Access Compliance Report

Public Rights-of-Way

(Curb Ramps)

Intersection ID: 43671	Main Street: ARMOUR RIDGE DR	Cross Street: ASHETON CREEK DR	Location: W
ADA ID: 01BD012A75B1	Ramp Type: PerpDiag	Initial Pass/Fail: Fail	Overall Compliance: No
Severity Score: 10			
Codes/Mitigation Info/Possible Solution		Field Measurements/Component Compliance

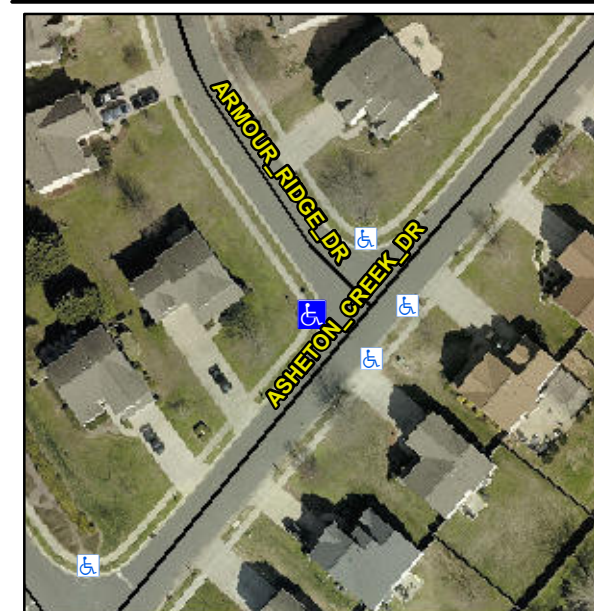
Not Found, R304.5.1, R304.5.3

Compliance	Description	Data	Compliance	Description	Data
N/A	Ramp Length (in)	45.5	Yes	Ramp Slope (%)	6.5
No	Ramp Width (in)	38.5	No	Ramp XSlope (%)	2.7
N/A	Flare Type LT	N/A	N/A	Flare Type RT	N/A
N/A	Flare Slope LT (%)	N/A	N/A	Flare Slope RT (%)	N/A
N/A	Flare Traversable LT?	N/A	N/A	Flare Traversable RT?	N/A
N/A	Landing Length (in)	N/A	N/A	DWS Provided?	N/A
N/A	Landing Width (in)	N/A	N/A	DWS Contrast?	N/A
N/A	Landing Slope (%)	N/A	N/A	DWS Length (in)	N/A
N/A	Landing X Slope (%)	N/A	N/A	DWS Full Width?	N/A
N/A	Landing Curb? (Y/N)	N/A	N/A	DWS Offset (in)	N/A
N/A	Shared Landing?	N/A			
N/A	Gutter Ponding?	N/A	N/A	Gutter Slope (%)	N/A
N/A	Gutter Lip Ht (in)	N/A	N/A	Gutter X Slope (%)	N/A
N/A	Painted X Walk1?	No	N/A	Painted X Walk2?	No
	X Walk 1 Direction	To SE		X Walk 2 Direction	To NE
N/A	X Walk 1 Width (in)	N/A	N/A	X Walk 2 Width (in)	N/A
	X Walk 1 Slope (%)	2.2		X Walk 2 Slope (%)	2.0
	X Walk 1 X Slope (%)	0.3		X Walk 2 X Slope (%)	2.8

Remove & Replace Curb Ramp With Two New Directional Ramps or Equivalent.
